CITY OF WARRENVILLE  
DuPage County, Illinois

ORDINANCE NO. O2017-59

**ORDINANCE APPROVING PRELIMINARY AND FINAL PLAT OF SUBDIVISION,  
PRELIMINARY AND FINAL PLANNED UNIT DEVELOPMENT (PUD) SPECIAL USE  
PERMIT AND PUD EXCEPTIONS, VARIATIONS AND/OR SPECIAL APPROVALS  
FROM VARIOUS PROVISIONS OF THE WARRENVILLE ZONING AND SUBDIVISION  
CONTROL ORDINANCES, AND LOCAL STORMWATER MANAGEMENT  
ORDINANCE (STAFFORD PLACE SUBDIVISION)**

EXHIBIT B: Review Memo from the Consulting City Engineer J.J. Benes and Associates, dated August 23, 2017.

**MOUNT STREET  
PLAN AND PROFILE  
STA. 10+00 TO STA. 16+71.22**

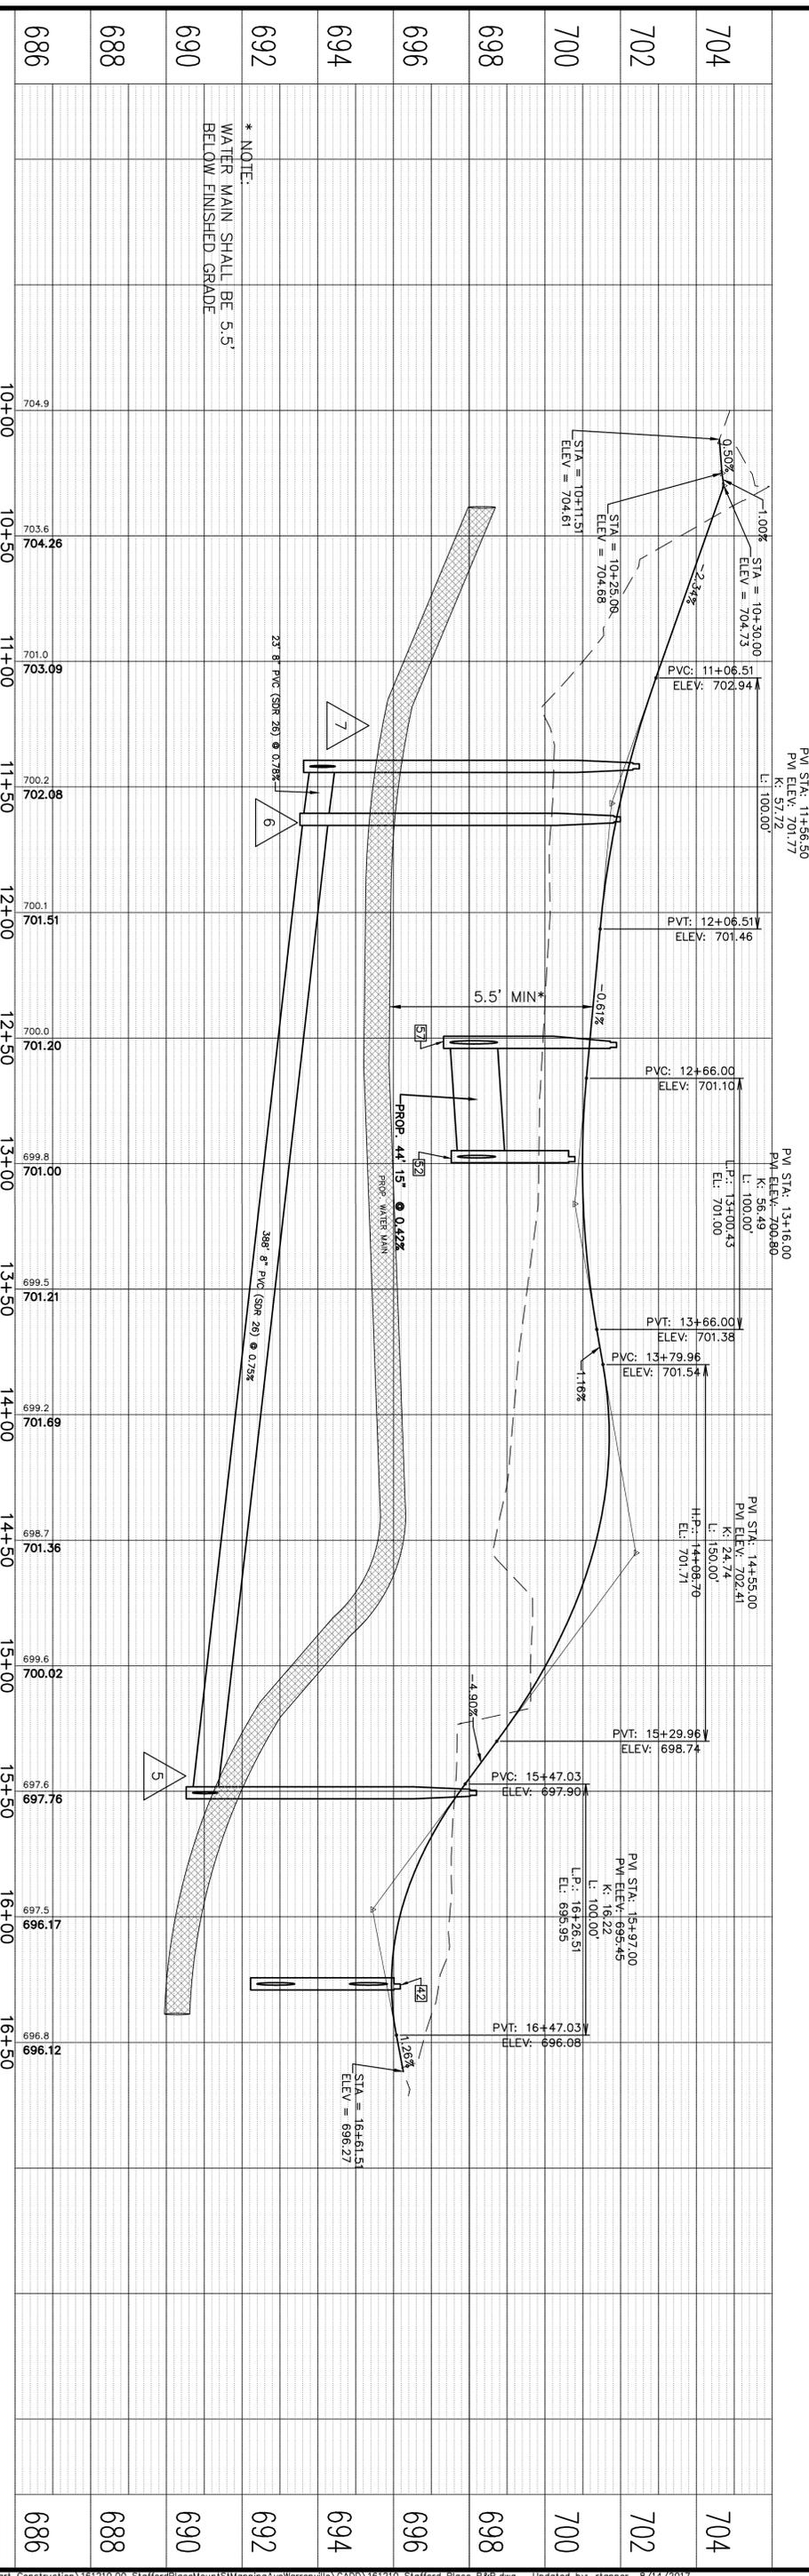
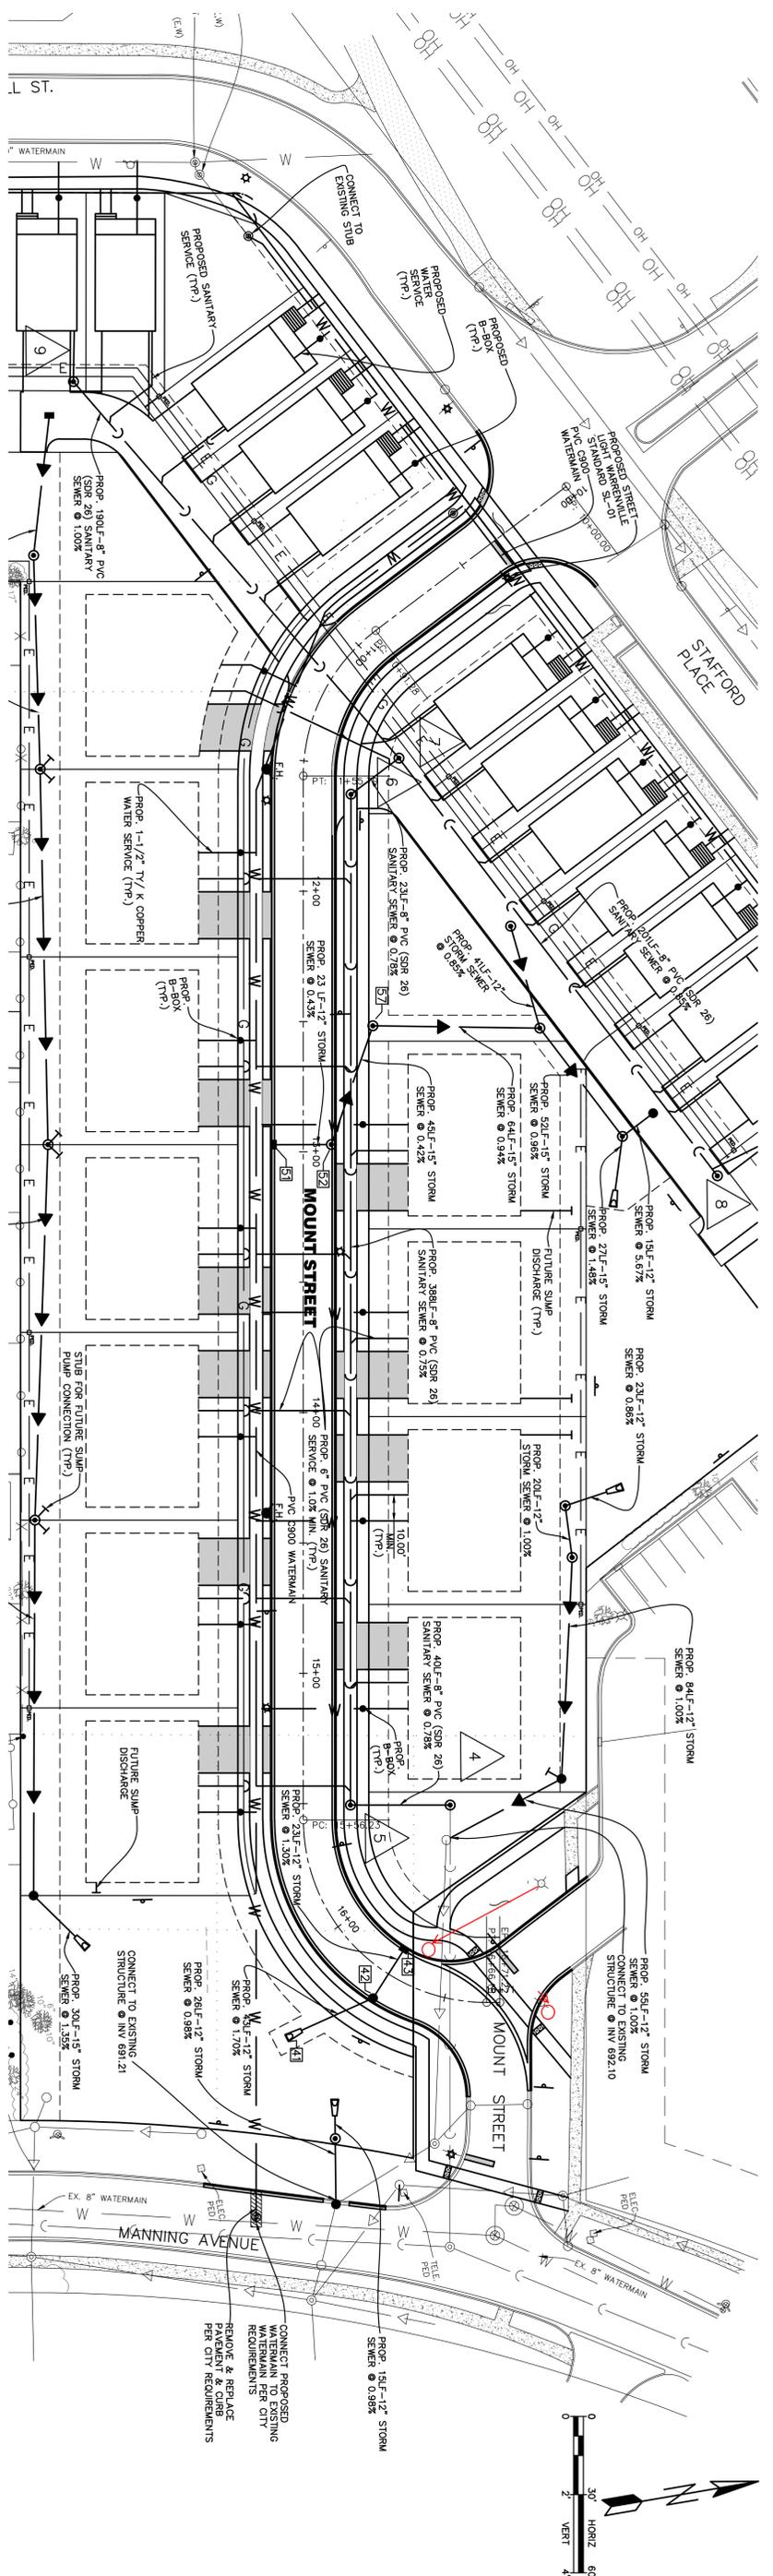
36. A 3.34% grade break-over is shown at Station 10+30 on the Mount Street profile. This creates a pronounced bump for drivers entering and exiting Mount Street. We recommend revising the profile to specify a -1% downgrade from Station 10+11.51 to Station 10+30.00 (EI 704.42) and then -2.09% downgrade to the PVI Station 11+56.50 (EI 701.77). Provide a catch basin at the northeast corner of the Mount Street/Stafford intersection to intercept Stafford Street runoff before it runs down Mount Street.

**City of Warrenville Standard SL-04  
Lighting Trench**

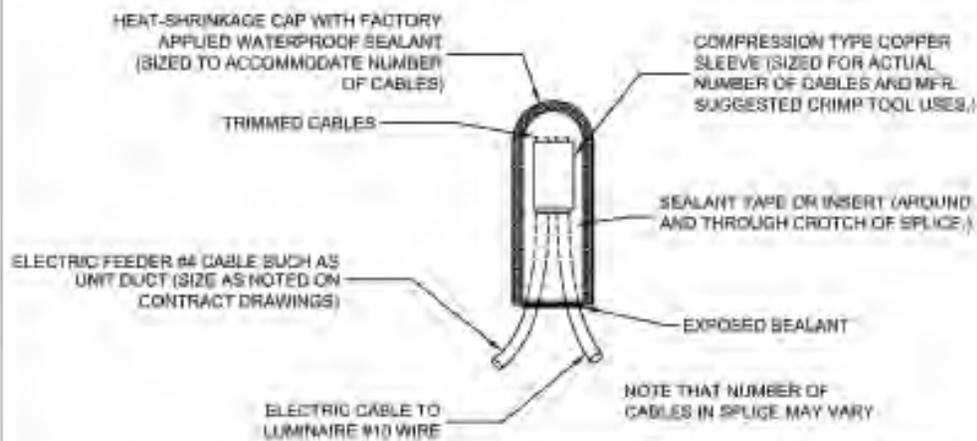
11. Update City Lighting Standard SL-03 and SL-04 per attached markups.
12. The east side-yard of Unit 3 shall be provided with a swale graded to direct site runoff to the rear to Outlot B, and to the front to the Ray Street right-of-way.
